No. WII/AE&CB/BH/Nagpur-Katol/2022-01

Dehradun, the July 12, 2022

Sub.: Review of proposed mitigation plan for upgradation of Nagpur – Katol Road (NH 353J) – reg.

Review of the Proposed Wildlife Mitigation Plan for Diversion of 14.07 Ha of Forest land for Upgradation of Nagpur-Katol section of NH 353J from Km 13+00 (Outer Ring Road, Nagpur) to 62+900 (End of Katol Bypass)

Figure 2. Realignment of NH 353J between chainage km. 54.075 and 55.800 to avoid fragmentation of the forest patch

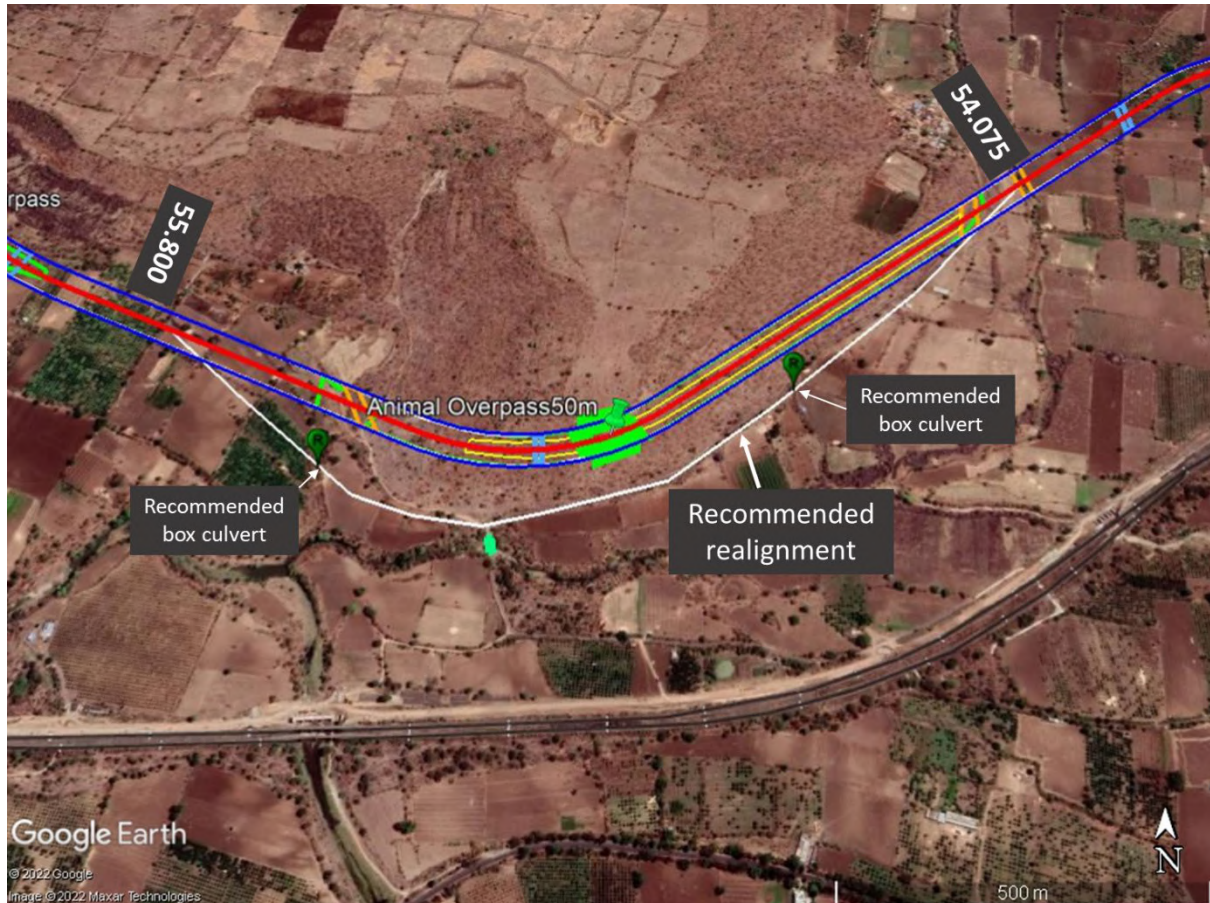
The proposed alignment between chainages 54.100 and 55.550 bisects an intact patch of scrub forest. Therefore, realignment of this section is recommended such that the highway goes around the patch and not through it (Fig. 2). Two additional box culverts are recommended on the realigned stretch, each measuring 20 x 5 m (Table 2).

Table 2. Details of crossing structures to be built on the realigned highway section between ch. 54.075 and 55.800.

S. No.	Location	Dimensions (m)
1.	21°15'47.93"N 78°37'29.44"E	20 x 5
2.	21°15'43.19"N 78°37'2.74"E	20 x 5

Figure 3. Wall-type division of bridge and (b) pillar-type division

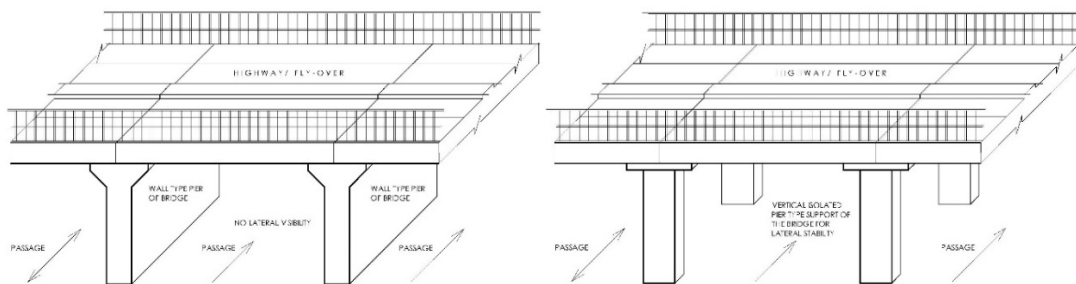
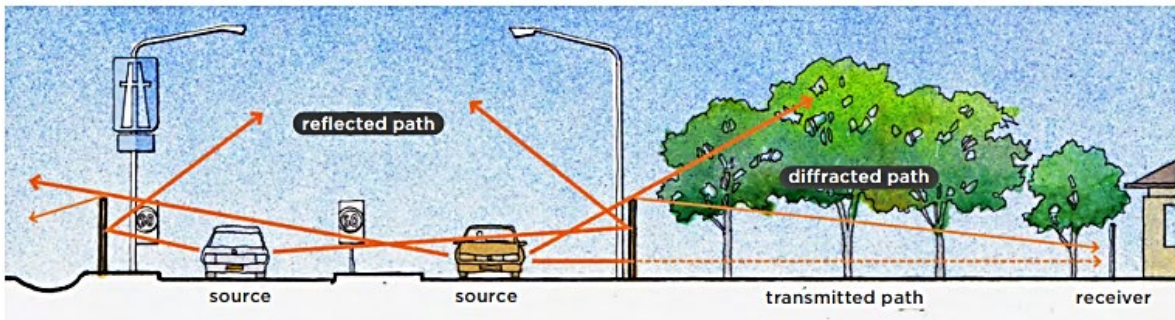
1. The height of all bridges, box culverts and other drainage structures (including those in agricultural areas) should not be less than 5 m. The minimum width of all box culverts should not be less than 5 m. The minimum height should not be achieved by ground excavation, but by elevating the road.
2. Divisions between the minor bridges should be of pillar type, instead of wall-type (Fig. 3).

Figure 4. Cattle guards/grids to be installed at both ends of the crossing structure on NH 353 at Chainage 60/350 and 61/050. (Source: Clevenger & Huijser 2011)

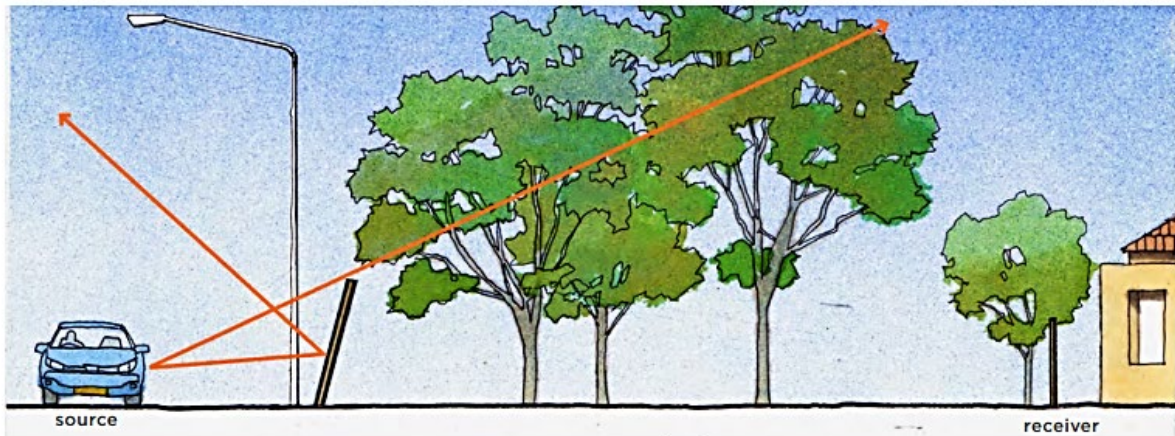
3. Noise and sound barriers 2 m high should be installed along the entire stretch of the highway passing through identified corridor area, which would also act as fencing to prevent animals from entering the road corridor. Additionally cattle guards (2 m wide) are to be installed at both ends of all structures to prevent wild and domestic animals from getting trapped within the fences/barriers (Fig. 4).
